SERVICE BULLETIN

ENGINE INDICATING – ENGINE VIBRATION MONITOR (EVM) HARNESS – MODIFICATION
OF CLIPPING POINTS CP0877, CP0879 AND CP1210

V2500 Series 77-0014

V2500-ENG-77-0014

REROUTING OF THE EVM HARNESS - V2500-A1 ONLY
FIGURE 1 SHEET 1

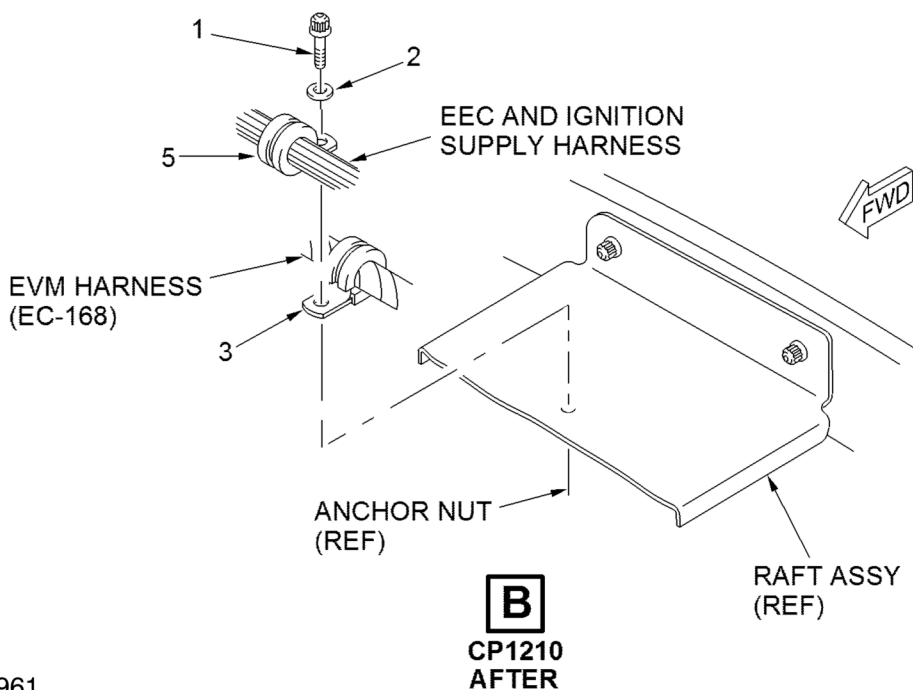
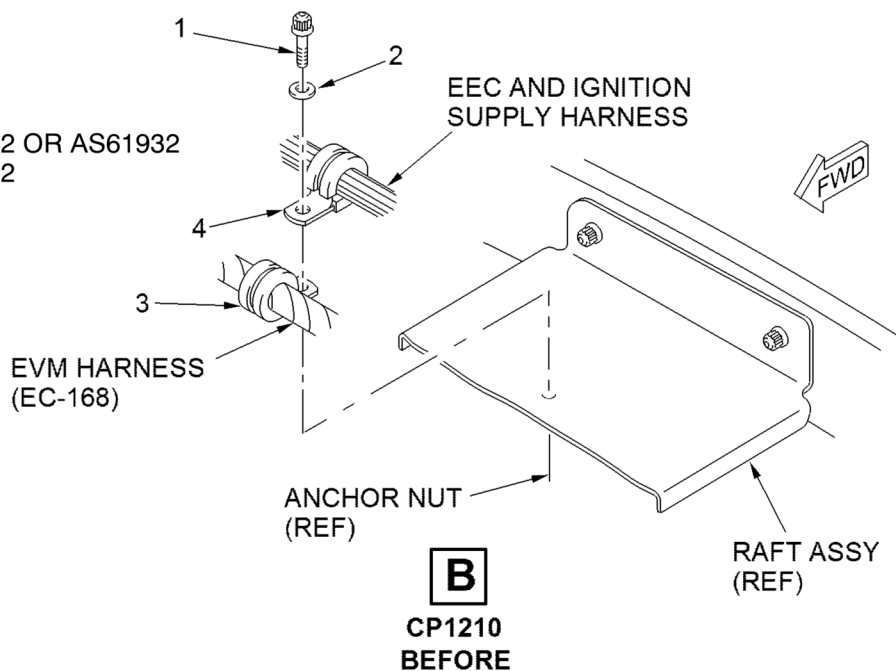
- A. At clipping point CP1210, remove the Bolt, PN AS21410 (1) and the Washer, PN SP154D (2), to release the EVM Harness and the EEC and Ignition Supply Harness from the Raft Assembly (ref). Refer to Figure 1, Sheet 1 and Sheet 2, View B (Before).
- B. At clipping point CP0877, remove the Bolt, PN AS21409 (5), the Washer, PN SP154D (2) and the Nut, PN AS20624 (6) to release the EVM Harnesses and the EEC and Ignition Supply Harness from the Raceway. Refer to Figure 1, Sheet 1 and Sheet 3, View C (Before).
- C. At clipping point CP0879, remove the Bolt, PN AS21408 (9), the Washer, PN SP154D (2) and the Nut, PN AS20624 (6) to release the EVM Harness and the EEC and Ignition Supply Harness from the Raceway. Refer to Figure 1, Sheet 1, and Sheet 4, View D (Before).

REROUTING OF THE EVM HARNESS - V2500-A1 ONLY
FIGURE 1 SHEET 2

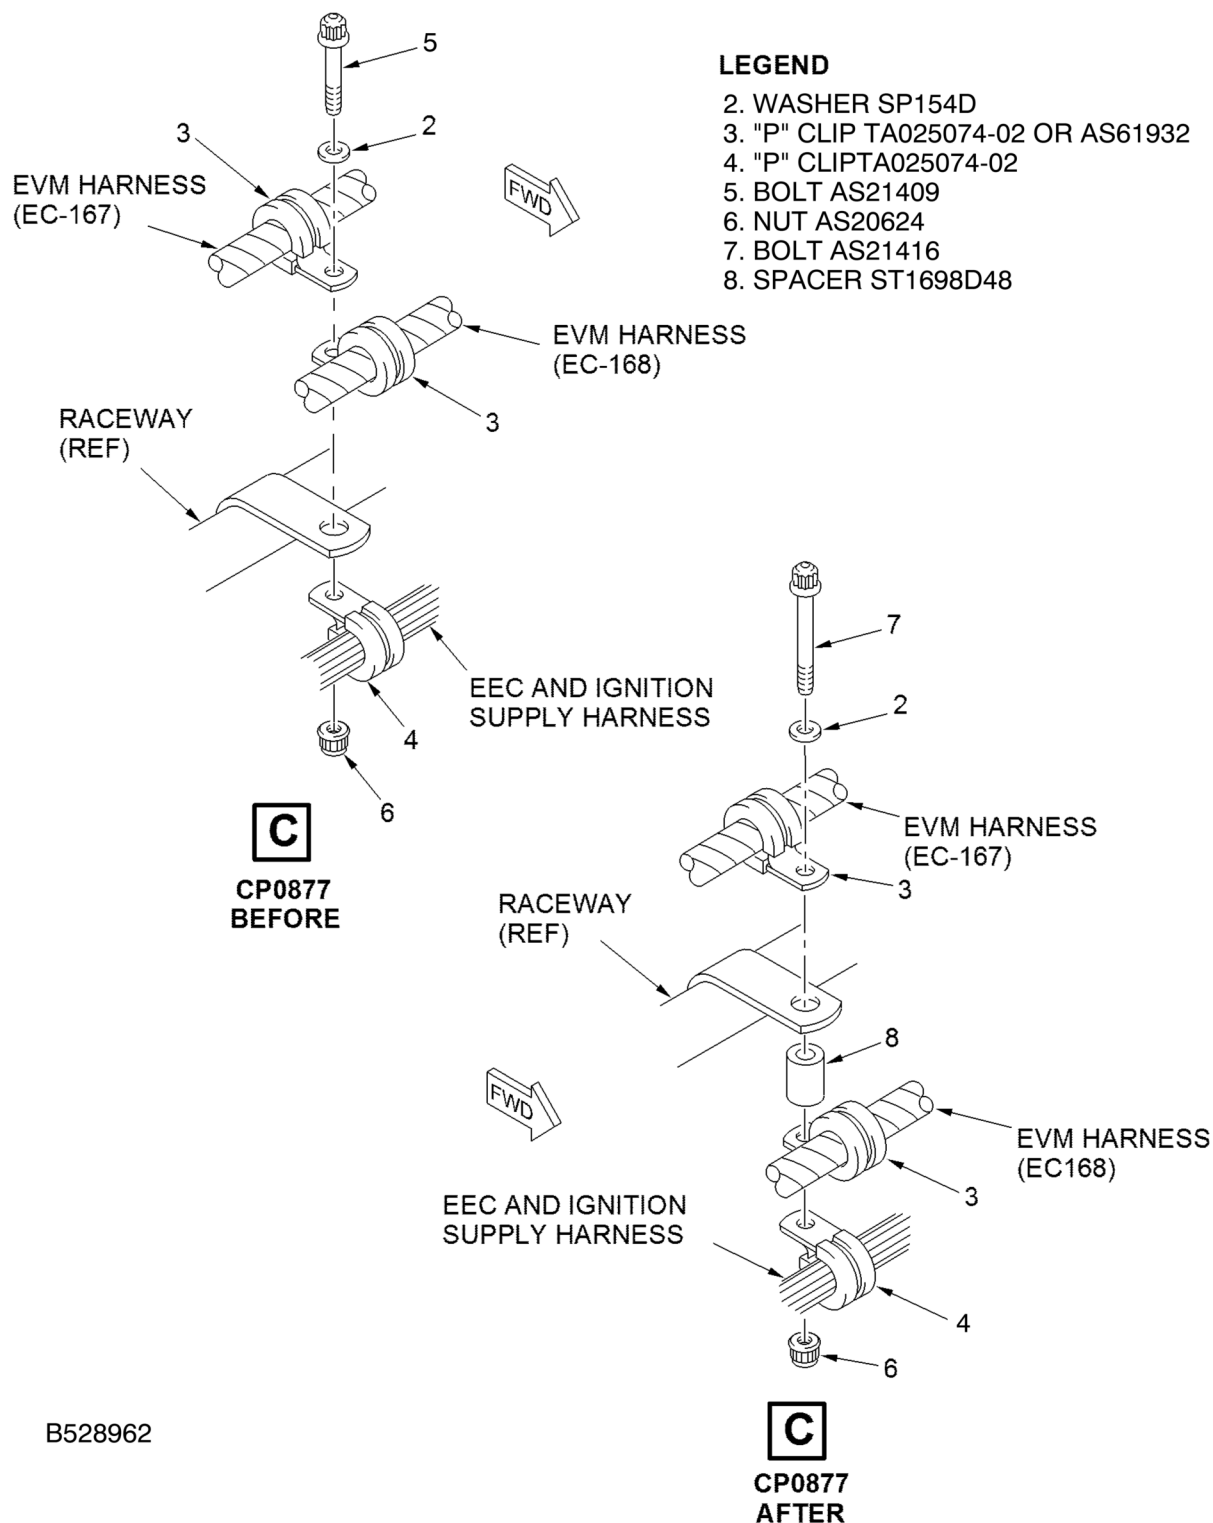
- D. At clipping point CP1210, attach the EEC and Ignition Supply Harness and the EVM Harness to the raft assembly (ref) with the 'P' Clip, PN TA025074-02, or PN AS61932 (3), the 'P' Clip, PN TA025074-02 (4), the Bolt, PN AS21410 (1) and the Washer, PN SP154D (2). Refer to Figure 1, Sheet 2, View B (After).

REROUTING OF THE EVM HARNESS - V2500-A1 ONLY
FIGURE 1 SHEET 3

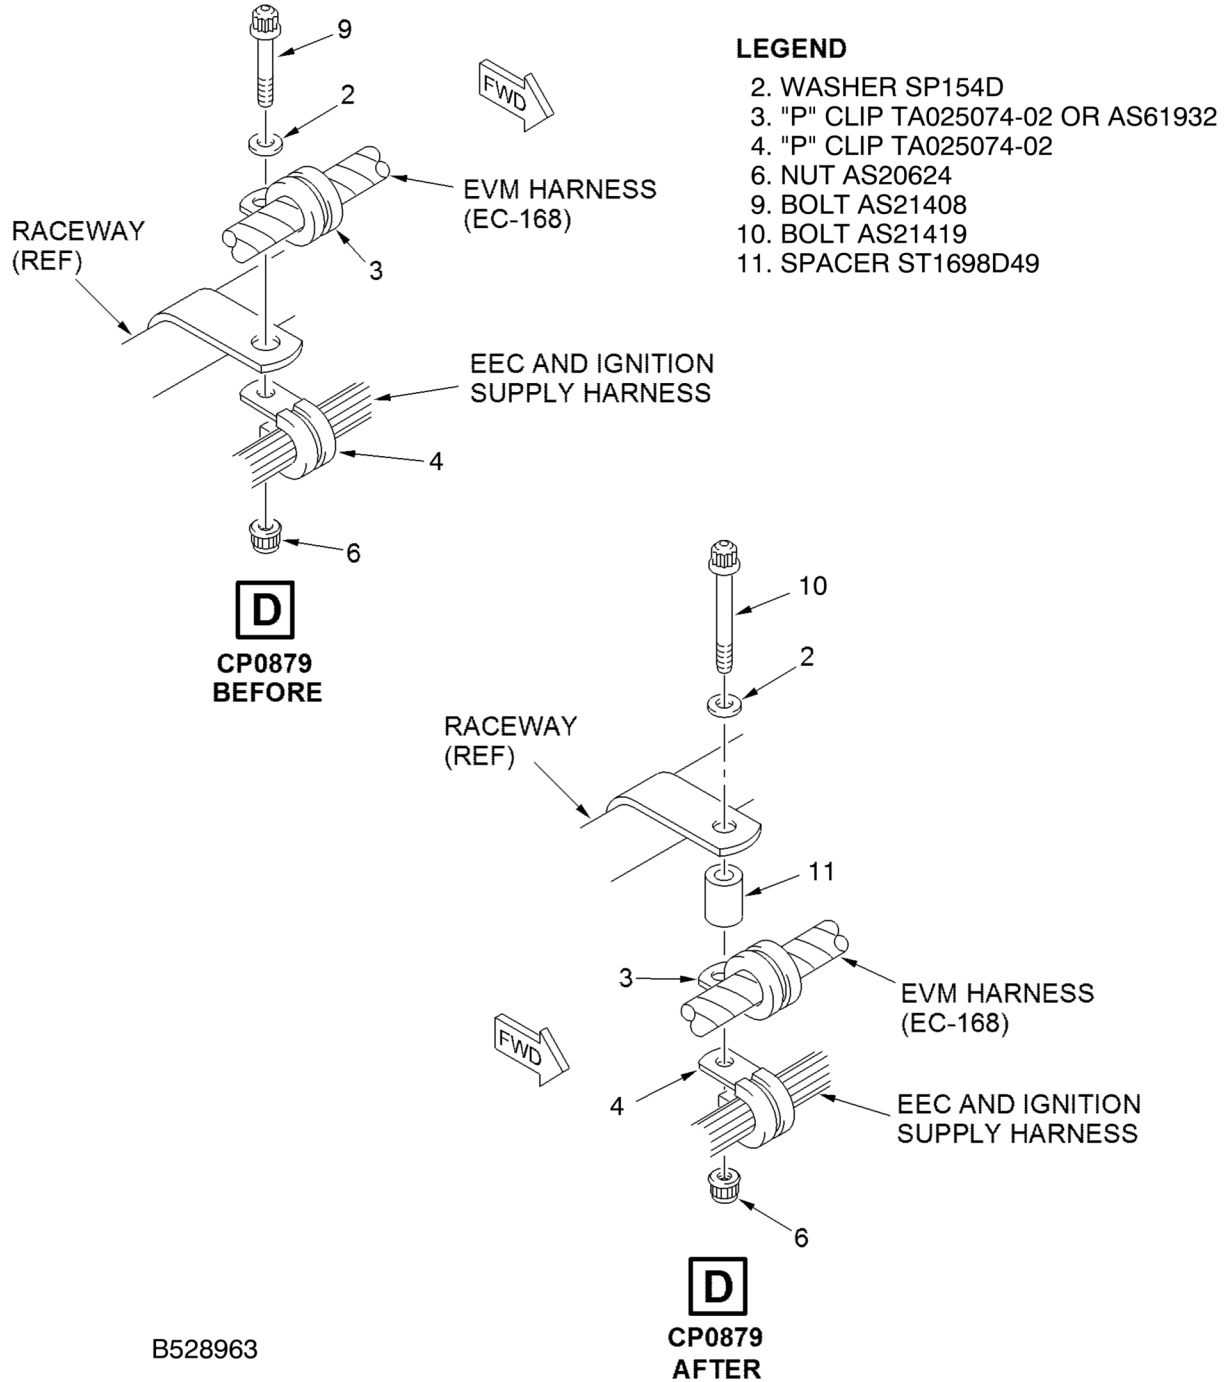
- E. At clipping point CP0877, attach the EEC and Ignition Supply Harness and the EVM Harnesses to the Raceway with the two 'P' Clips, PNs TA025074-02, or PN AS61932 (3), the 'P' Clip, PN TA025074-02 (4), the Bolt, PN AS21416 (7), the Washer, PN SP154D (2), the Spacer ST1698D48 (8) and the Nut AS20624 (6). Refer to Figure 1, Sheet 3, View C (After).

REROUTING OF THE EVM HARNESS - V2500-A1 ONLY
FIGURE 1 SHEET 4

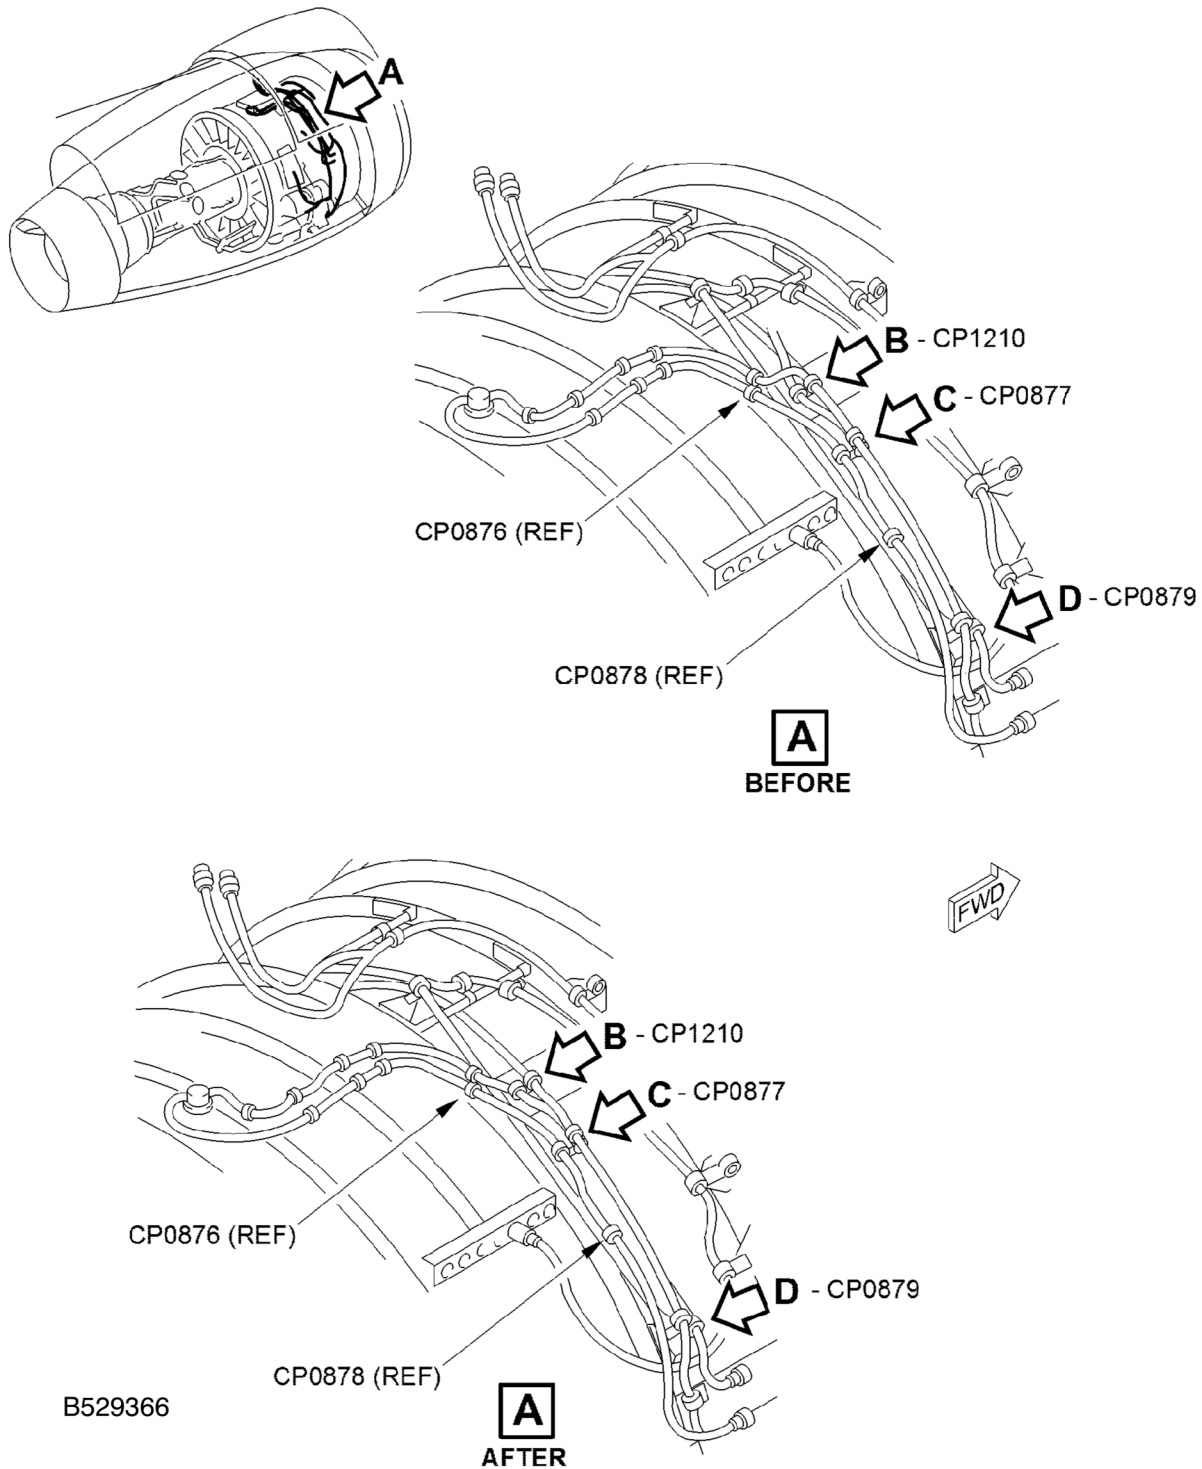
- F. At clipping point CP0879, attach the EEC and Ignition Supply Harness and the EVM Harness to the raceway with the 'P' Clip, PN TA025074-02, or PN AS61932 (3), the 'P' Clip, PN TA025074-02 (4), the Bolt, PN AS21419 (10), the Washer, PN SP154D (2), the Spacer, PN ST1698D49 (11) and the Nut, PN AS20624 (6). Refer to Figure 1, Sheet 4, View D (After).

REROUTING OF THE EVM HARNESS - V2500-A5 ONLY
FIGURE 2, SHEET 1

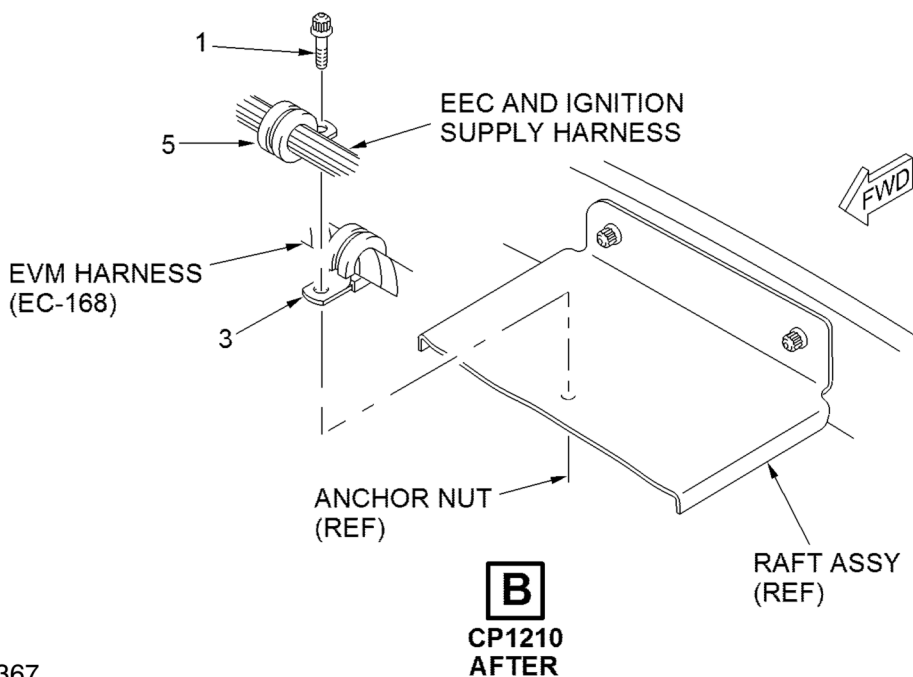
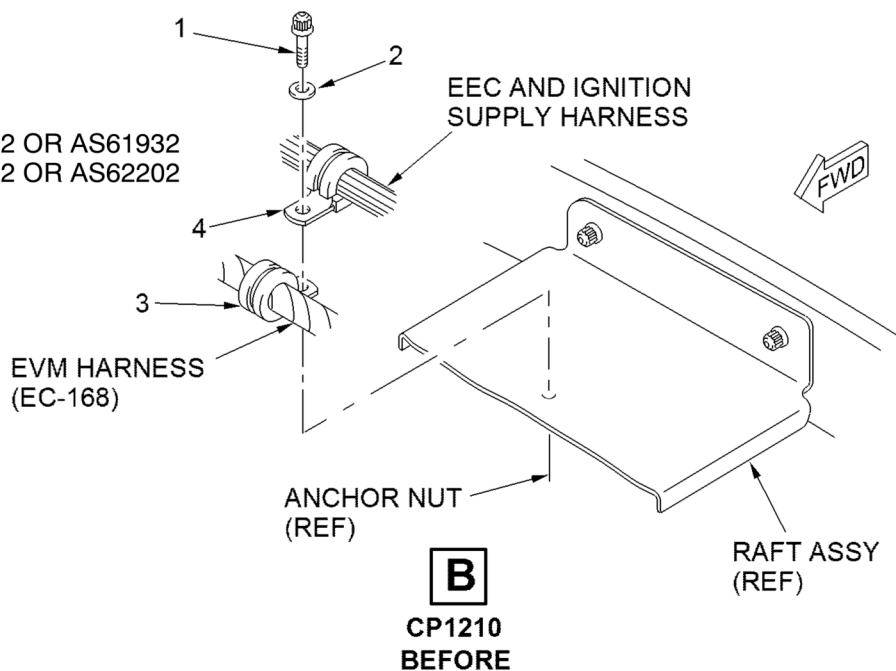
- A. At clipping point CP1210, remove the Bolt, PN AS21410 (1) and the Washer, PN SP154D (2), if applicable, to release the EVM Harness and the EEC and Ignition Supply Harness from the Raft Assembly (ref). Refer to Figure 2, Sheet 1 and Sheet 2, View B (Before).
- B. At clipping point CP1210, if the 'P' Clip, PN TA025074-02 (4) is fitted to the EEC and Ignition Supply Harness then remove the 'P' Clip from the harness and replace with 'P' Clip, PN AS62202 (5). Refer to Figure 2, Sheet 2, View B (After).
- C. At clipping point CP0877, remove the Bolt, PN AS21409 (6), the Washer, PN SP154D (2) and the Nut, PN AS20624 (8) to release the EVM Harnesses and the EEC and

REROUTING OF THE EVM HARNESS - V2500-A5 ONLY
FIGURE 2, SHEET 2

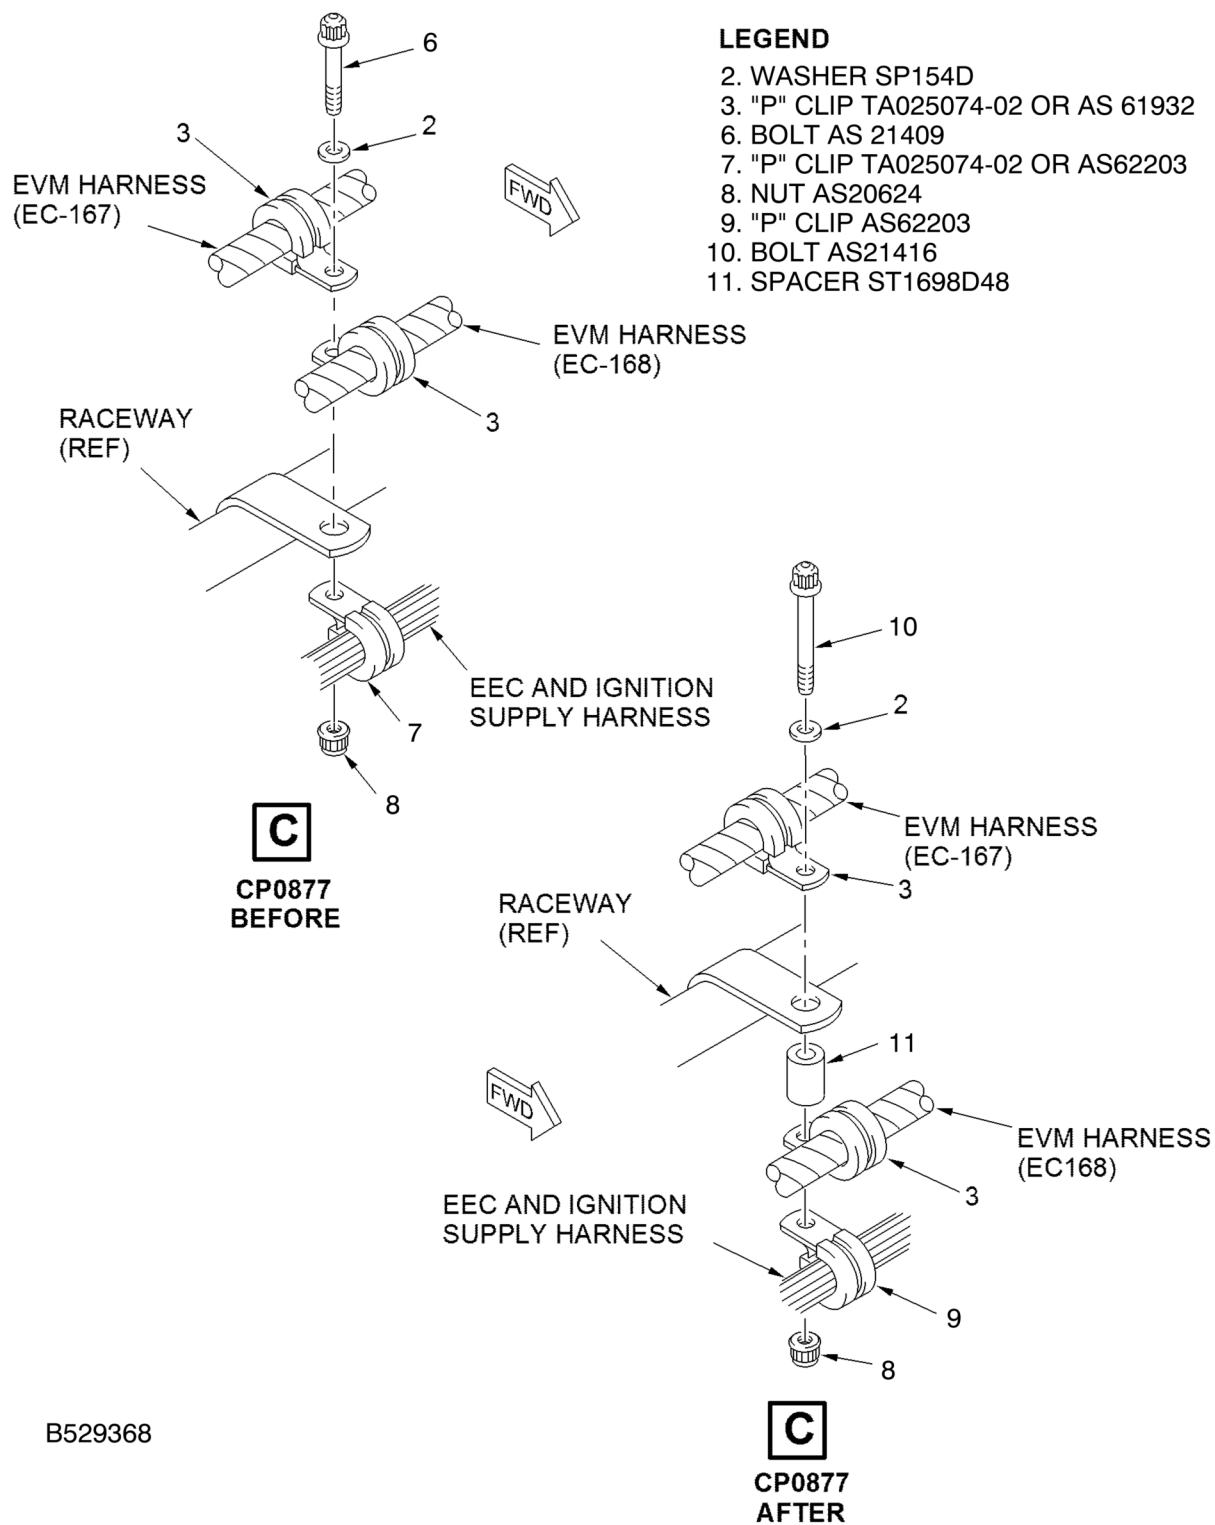
- G. At clipping point CP1210, attach the EEC and Ignition Supply Harness and the EVM Harness to the raft assembly (ref) with the 'P' Clip, PN TA025074-02, or PN AS61932 (3), the 'P' Clip AS62202 (5) and the Bolt AS21410 (1). Refer to Figure 2 sheet 2 view B (After).
